PS ref: 8433

18 January 2023

**LOT 100 (109) PALMERSTON STREET, PERTH 6000**  
**OBJECTION TO PROPOSED DEVELOPMENT OF FOUR GROUPED DWELLINGS**  
**UNACCEPTABLE LEVEL OF OVERSHADOWING TO ADJOINING PROPERTY**

**Figure 1** – Overshadowing analysis with the strata lot boundaries included

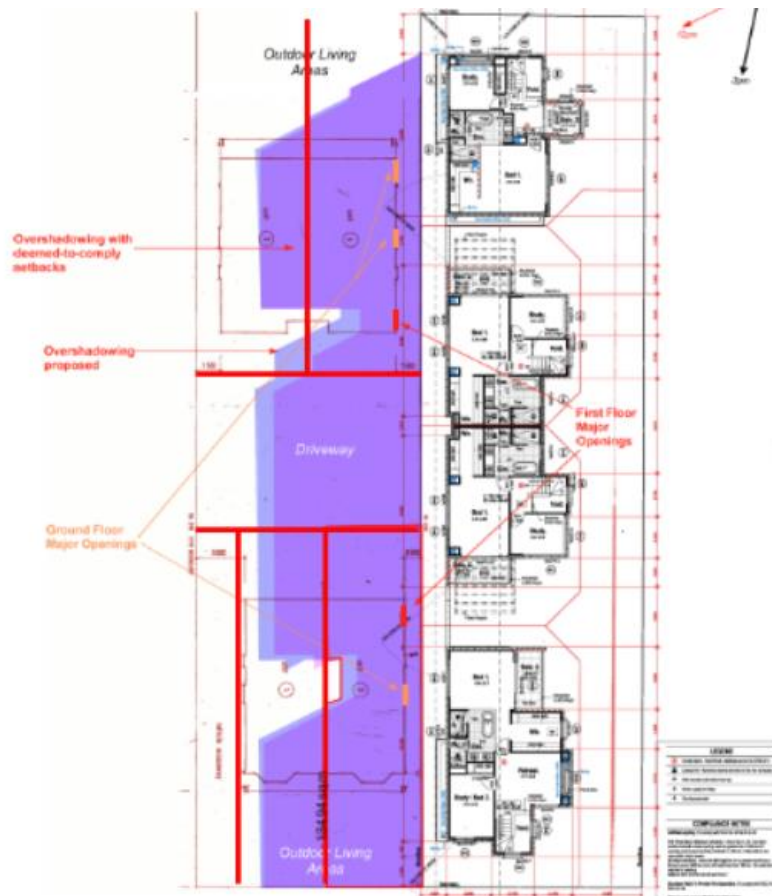
In fact, the extent of the impact is masked somewhat by reference to the overshadowing of the overall site only. A more individualised assessment of the impact upon the individual neighbouring dwellings within the development (excluding driveway areas) demonstrates the full extent of overshadowing:

- The residents of **Unit 1** will experience overshadowing of **74%**, meaning that the majority of their outdoor living area will be cast in shade by this development.
- The residents of **Unit 2** will experience overshadowing of **95%** including the complete overshadowing of their outdoor living area and the obstruction to daylighting of five of their windows.
- The residents of **Unit 4** will experience overshadowing of **73%**, with half of their outdoor living area cast in shade and daylighting to five of their windows completely obstructed.

This can be seen more clearly by showing the internal lot boundaries on Figure 1 below.

It clear the only compromise here is by the neighbouring residents and owners of No. 107, the majority of whom will have to live with their outdoor living areas being in shadow for much of the day, 4 months of the year. The proposed overshadowing will also result in the blocking of direct solar access to a number of the major openings to habitable rooms.
